ADDENDUM NO. 2

CP005941 – KIOWA – Lab Addition

To: All Bidders
From: John H. Sattler, DCS Inc.
On behalf of University of Colorado, Boulder
Date: September 7, 2010
Distribution: File, Jennifer Sample, John Paul Robb

CU KIOWA LAB ADDITION - MOCK-UP

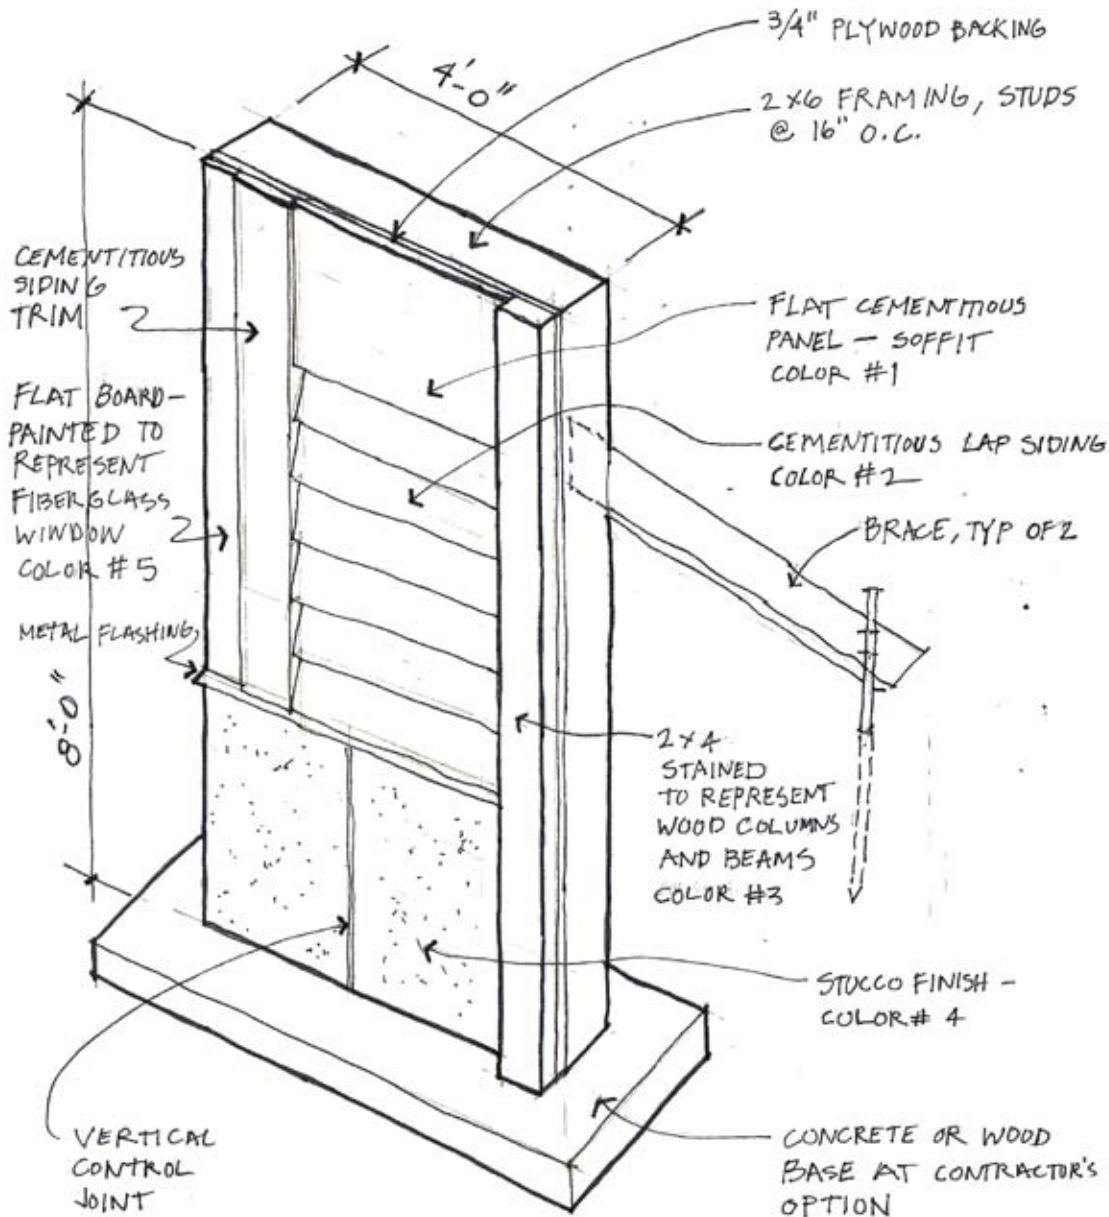
- A2.15 Wall Finish Mock-ups: The CU Design Review Board requested that 3 mock-ups be constructed to assist in the process of final color selections for exterior materials. The attached sketch shows the typical mockup to be constructed on the site, in a location suggested by the contractor, and approved by the architect. Mockups construction shall be scheduled to allow CU and Architect review time prior to material installation.
